S.I. No. M20-46

SUBJECT: RELOCATION OF COWL SNUBBERS, P/N J-7444-14

MODELS/SERIAL  
NUMBERS AFFECTED: M20K - S/N 25-0001 thru 25-0146

FIGURE 1

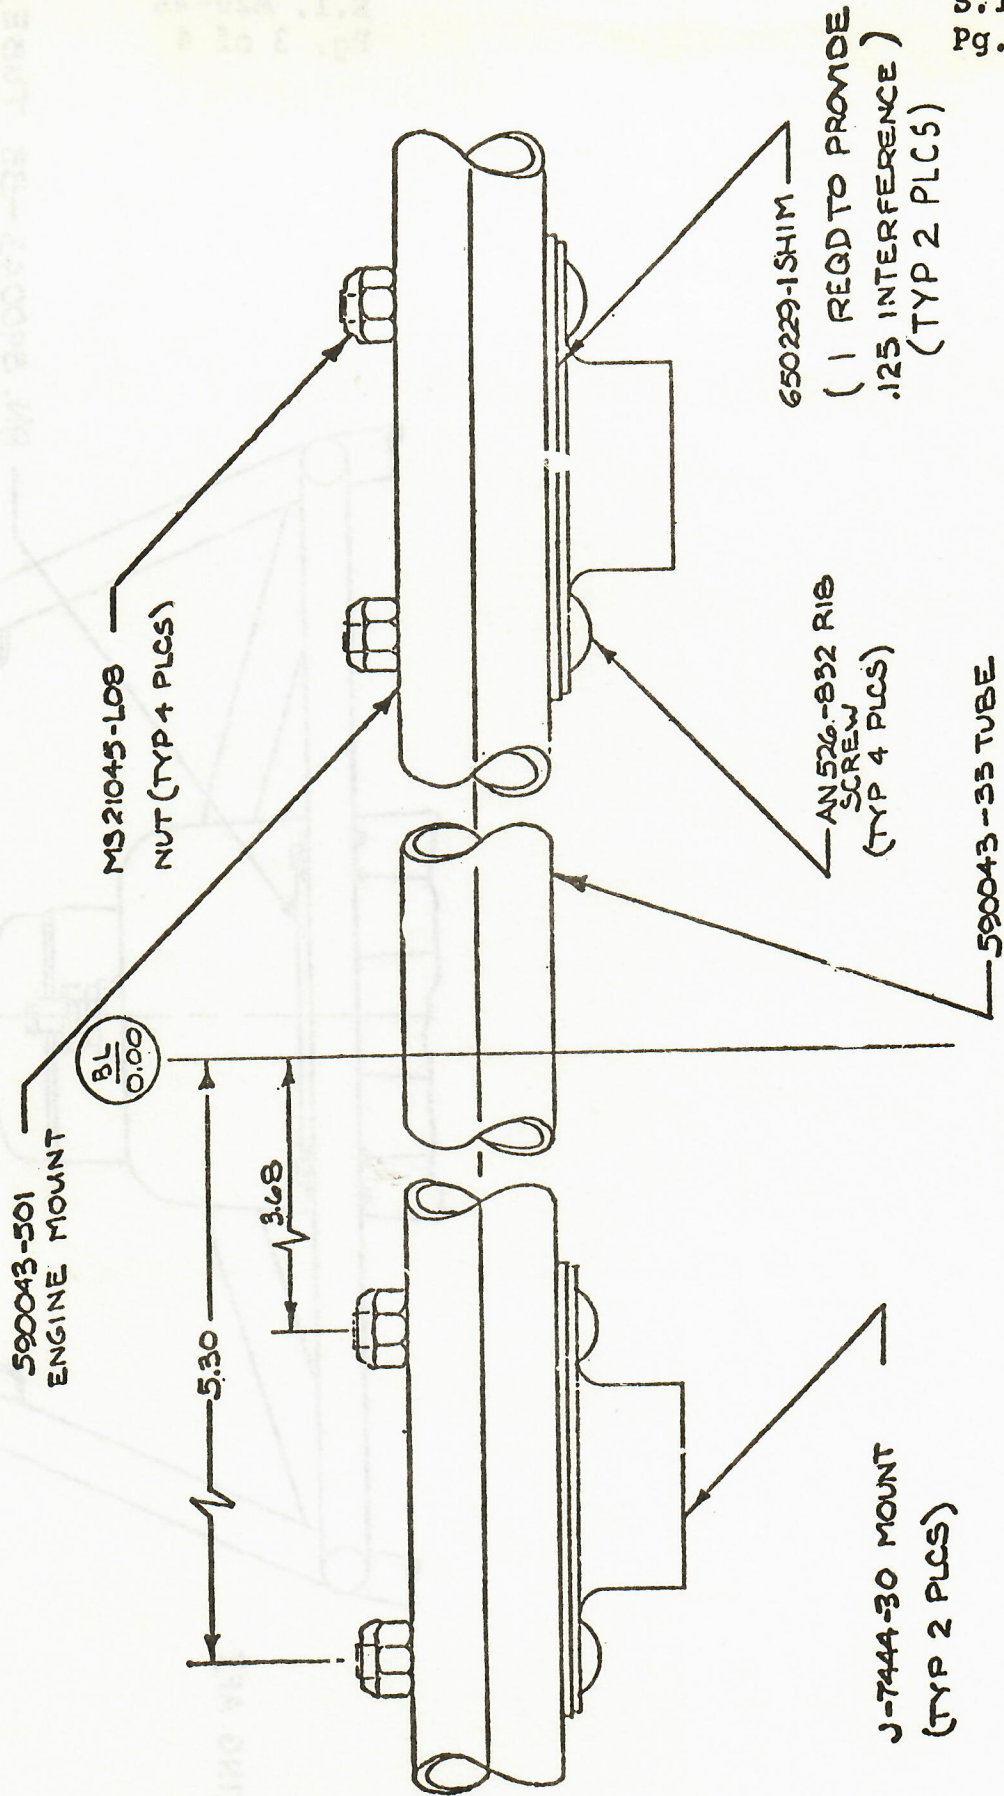
- 3) Reference Figure 1 for proper location area of the Lord shock mounts and related hardware.
  - 4) Reference Figure 2 for dimensions and sequence of modified snubber installations. Obtain butt line 0.00 by measuring from outside of engine mount tube to exact center line of engine mount assembly on tube P/N 590043-33. Locate and drill 4 ea. .166/.177 holes (vertical) for left and right hand mount installations per dimensions shown.

PN. 590043-33 TUBE.  
FOR COWL SUPPORT MOUNTS.  
INSTL-SEE  
NEXT SHEET

- 5) Assemble the new Lord shock mounts, P/N J-7444-30, shims, P/N 650229-1 with new longer screws P/N AN 526-832R20 and nuts, MS 21045-L08 as depicted on Figure 2. Apply RTV 102 to screw head, between 650229-1 shim and 590043-33 tube and between tube and nut. Seal around nut after tightening for moisture seal of tube interior.
- 6) Reinstall lower and upper cowling per Service Manual. Reconnect all electrical and mechanical connections.
- 7) Enter compliance record into aircraft log book.
